MAYFAIR SOLAR FARM

Response to Submissions Report – SSD-60074458

Report Number SSD-60074458 RTS Report 17.7.2025

Figure 5 Number of project workers and on-site accommodation beds.

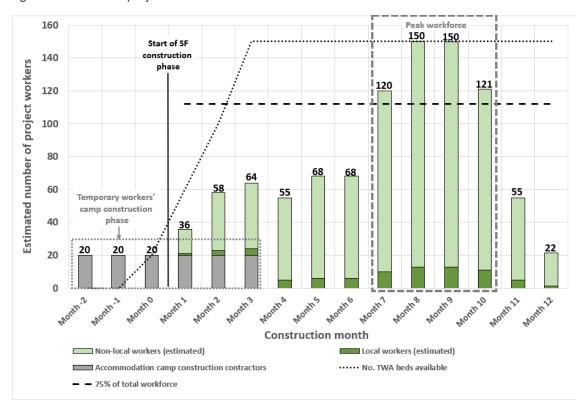
Council identifies a lack of completeness in the Interim workforce and accommodation plan in relation to Hotels and Motels being available for construction workers. Council advised that these accommodation types are also used as tourist accommodation. As such, Council does not support the use of existing visitor accommodation for the construction workforce and would like consideration of the cumulative impact of other State Significant Projects occurring the area, to be considered to minimise such impact.

In response, further assessment within the Workforce Accommodation Plan has been undertaken. The accommodation camp construction contract will be awarded to a contractor specialising in the provision of temporary worker camps and would likely require 20 specialist personnel. The construction of the camp is expected to commence three months prior to commencing construction of the solar farm. However, it will take approximately six months for the full scale of the camp to be constructed as it will scale as the number of workers are required on site.

It has been estimated that approximately 20 construction workers will likely require local short-term accommodation (or alternative TWA camps if available) for a limited time (approximately eight weeks) to commence construction of the temporary workers' accommodation (TWA) camp. These construction workers will then transition into the TWA once accommodation is available.

Figure 5 shows the number of project workers against the project's timeline, together with the anticipated onsite accommodation capacity and shows that accommodation will become available from month zero and that all project workers (TWA camp construction and solar farm construction workers) will be accommodated on-site.
